Amendments/Additional Information

Station Waiting Rooms,
Robin Hoods Bay,
North Yorkshire.
YO22 4RA

Re. Application No: NYM\2016\0506\FL - Station Waiting Rooms

OLD STATION WAITING ROOMS - ROBIN HOODS WAY
 PROPOSED ALTERATIONS TO TOILET BLOCK 1:50

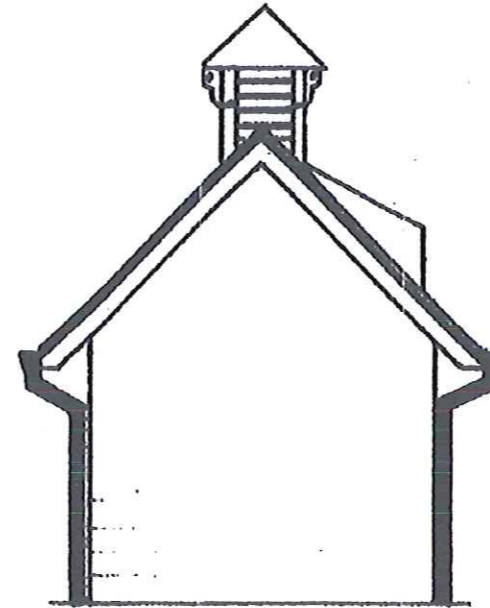
Existing redundant
 vent to be
 removed

Cast iron guttering to all
 elevations to be restored.
 Cast iron fall pipes to be repaired
 and restored.

Windows to be hardwood
 sliding Sash with Horns
 to match existing.
 Doors to be Panelled
 and beaded to match
 existing.

- 1) Install 2 N° Velux Vertical/Horizontal Windows
 1140 Wide x 600 Vertical.
- 2) Install 1 N° Velux Centre Pivot Window to Stain Well
 472 Wide x 550 High
- 3) Lower 4 N° Existing Windows & Stone Cills Approx.
 300mm To Accomodate Proposed 1st Floor Level.

- 1) Install 2 N° Top Hung Velux Windows 1140 Wide
 1600 High. To be Conservation Type With Glazing
 Bars. Utilising Recessed Flashings
- 2) Utilising Existing Vertical Window Reveals, Install 2 N°
 Windows (Heights to Match Remainder of Windows)
 Existing Heads to be lowered approx. 300mm To Accomodate
 Proposed 1st Floor Level.
